From: Amy Wolanski <amy@whaleback.co.uk>
Sent: 24 February 2026 15:09:03 UTC+00:00
To: "Halima.Chowdhury" <Halima.Chowdhury@horsham.gov.uk>; "Trees" <trees@horsham.gov.uk>
Cc: "Andrew.Clout" <Andrew.Clout@horsham.gov.uk>
Subject: RE: DC/25/2149, Jarvis, Jarvis Lane, Steyning,
Attachments: Jarvis_Typical section through driveway.pdf

Erection of a single storey in-fill extension to rear elevation. Repair, restoration, selective alterations, including window repairs/replacements. Construction of a new driveway, and associated works (Householder).

POROUS PAVER/GRAVEL GRID WEARING COURSE

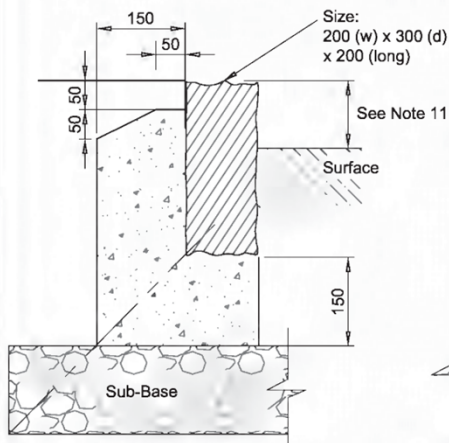
For the main run of driveway up to the parking area the detailing would be best taken from this Core product sheet, (please see the link below), there are a number of similar products on the market, however the images in their brochure are very good, it would be advisable to specify the 150mm base TRP panel as the CBR is unlikely to be above 3.

A 10/14mm natural stone shingle aggregate to provide the finished wearing course and a tanilised wooden edging providing the edge restraint (minimum thickness 22mm)

**FULL HEIGHT KERB
TYPE GRANITE SETT**
(1:10)

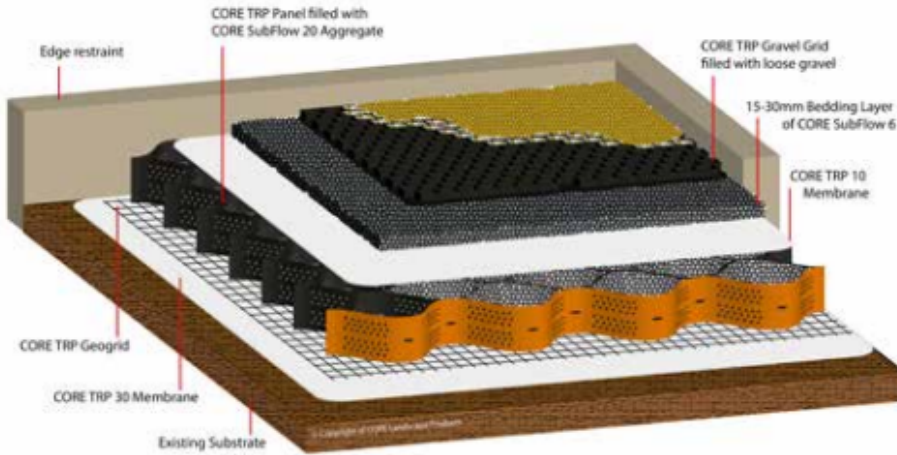
The same system can be used in the parking area itself as it minimises excavation here, in this area it could be excavated to a more suitable level (finished level 100mm below EGL to allow for a suitable natural stone edging which could have a 150mm concrete foundation (see granite sett detail below)
